PLANT HATCH - UNITS 1, 2
NRC DOCKETS 50-321, 50-366
OPERATING LICENSES DPR-57, NPF-5
REQUEST FOR ADDITIONAL INFORMATION
MSIV CLOSURE TIME TECHNICAL SPECIFICATIONS AMENDMENT

PLANT HATCH - UNITS 1, 2
NRC DOCKETS 50-321, 50-366
OPERATING LICENSES DPR-57, NPF-5
REQUEST FOR ADDITIONAL INFORMATION
MSIV CLOSURE TIME TECHNICAL SPECIFICATION AMENDMENT

IMPACT OF 8-SECOND CLOSURE TIME ON ENVIRONMENTAL QUALIFICATION

**FIGURE 1 COMPARISON OF MSLB INTEGRATED BREAK ENERGY
(20% OVERSIZED BREAK)**

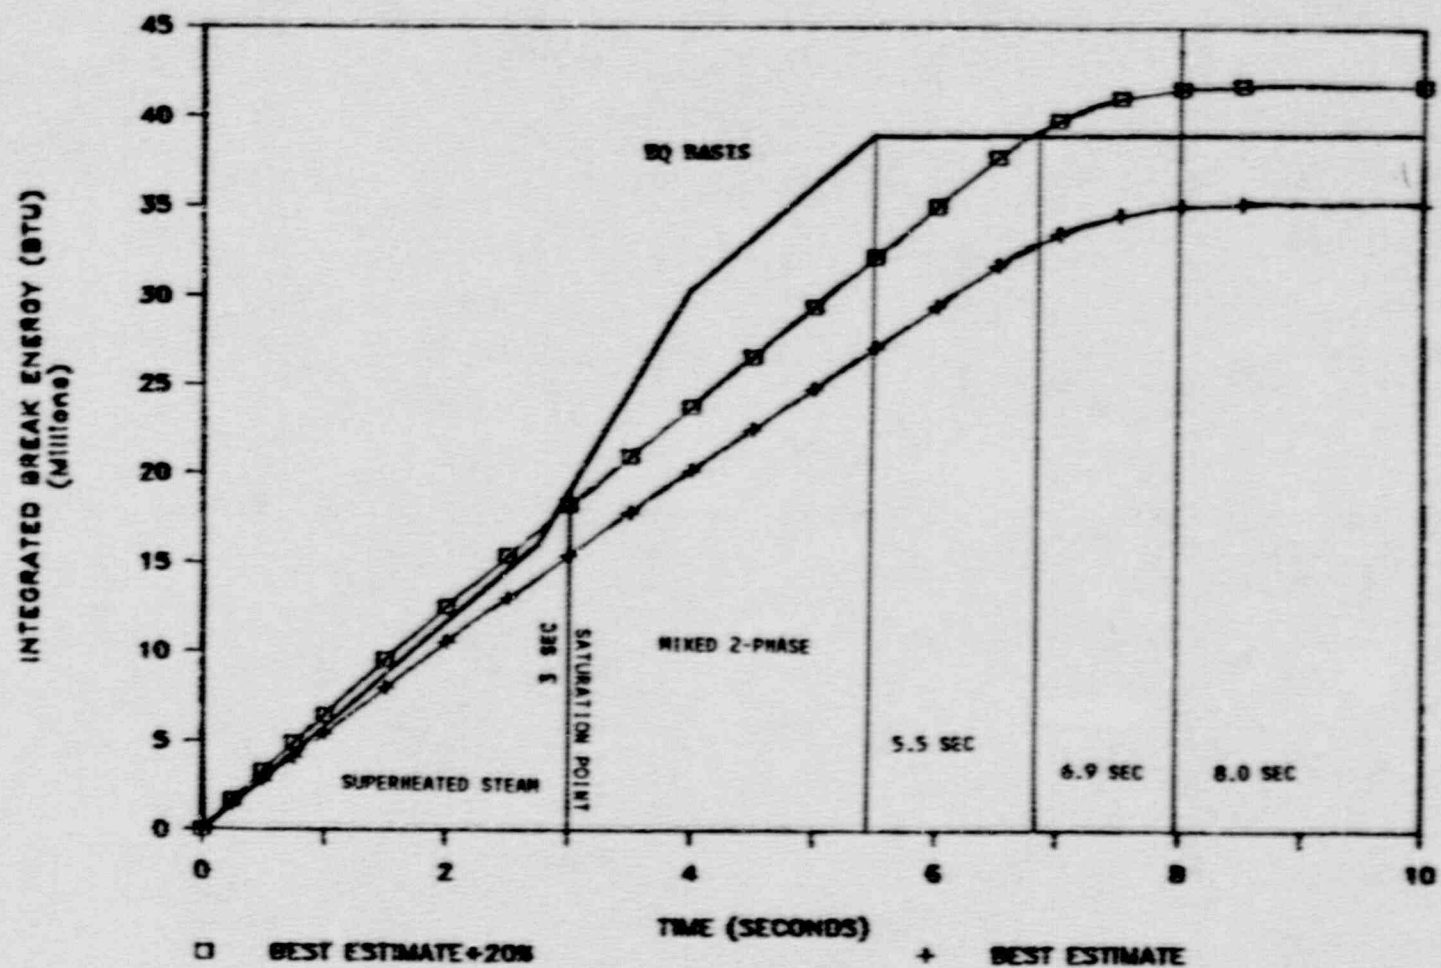
GPC should provide a qualitative argument as to whether existing MSLB temperature versus time EQ profiles bound the temperature versus time profile expected to result from the new mass and energy release estimates calculated using SAFER with an 8-second MSIV closure time.

Figure 1 presents the integrated break energy versus time as calculated using the SAFER Code. The same figure is also shown in the GE report (Enclosure 2) and assumes a 20% larger break area to conservatively account for calculational uncertainties. Note that the integrated break flow calculated using SAFER is bounded by the existing EQ basis break flow, even with the longer stroke time and a 20% larger break area assumed in the SAFER calculation.

The time history shown in Figure 1 has been marked at several points of interest. The first point of interest is at 3 seconds when the mass flowing into the room becomes two phase after flashing. From this time on, the room temperature can be no higher than the saturation temperature of the water which is flashing at room pressure. Since the room pressure is only slightly above one atmosphere, the limit of the room temperature is approximately 215°F.
